Addendum No. 1

City of Coquitlam
Tender 72486

MRN Como Lake Pavement Rehab – Eastbound Lanes

Issue Date: April 4, 2022
(Consists of 4 Pages)

Scale **1:500** Scale **1:500**
horiz. of **11**
Sheet **11** of **11**
Eng. Project No.

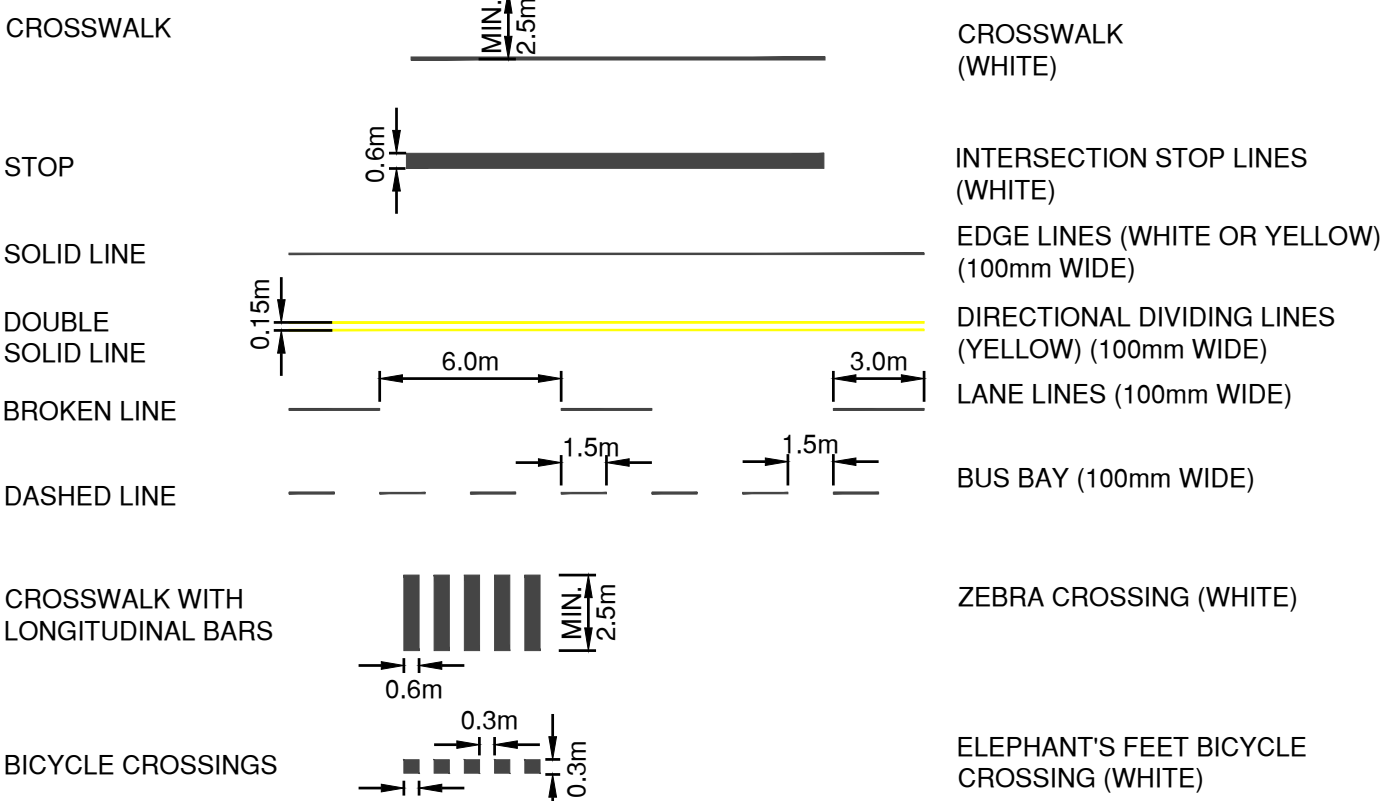
Note: Some quantities have increased to reflect expanded scope on Sheet 11 of 11.

ADD: 3.1.4 Work depicted on Sheet 11 of 11 (Como Lake Mariner Way intersection) must be completed between the working hours of: **09:00 hrs. to 15:00 hrs.**

ADD: Sheet 11 of 11 (STA. 5+510 – STA. 6+580)

Note: Includes pavement rehabilitation through the Como/Mariner intersection which will be over top of the new Fortis IP main approximately aligned in the eastbound left-turn-only lane onto Mariner Way northbound.
